Report ID: 2014-00183

Title: (Agreement/Contract for Review and Information) Contract: Wild Rose Park Development (L19187000)

Wild Rose Park is a 9.6-acre community park located at 5200 Kankakee Drive in North Natomas Council District 1.

EXHIBIT #1

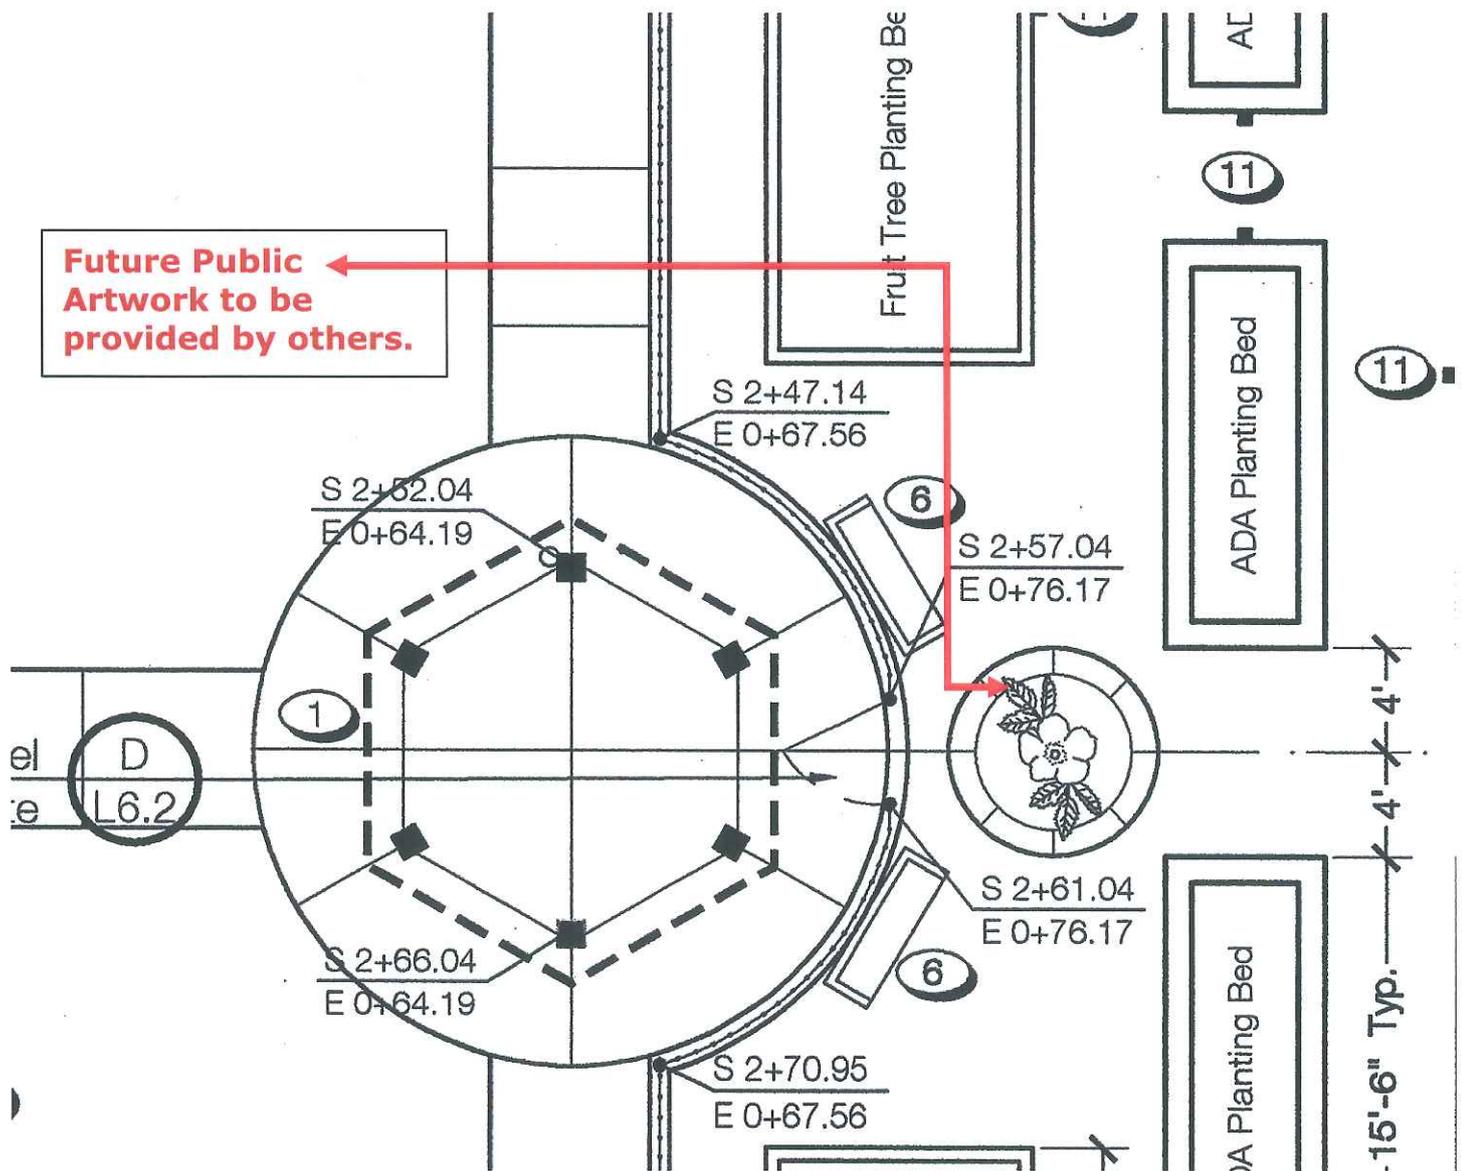
1. Revision: Sheet L1.6, Detail A –Community Garden Enlargement, Add the following text to the flower design in front of the shelter: "Future Public Artwork to be provided by others." See attached Exhibit #1.
2. Addition: Sheet L1.1, Add Alternate Bid Item #3 – Demonstration Garden, Refer to Detail E – Boulder Placement Add Alternate #3 on Sheet L6.8 for the legend callouts from "A-C". Refer to the attached Exhibit #3 for callout "D". Callout "D" was intended to be various sizes of washed river cobble to mimic a dry creek bed. The cobbles shall be installed with larger cobbles towards the outer edges of the creek bed with a greater concentration of smaller cobbles in the center of the creek bed.

Sheet L1.6 per plan set, Detail A –Community Garden Enlargement,
 Add the following text to the flower design in front of the shelter: "Future
 Public Artwork to be provided by others." See below.
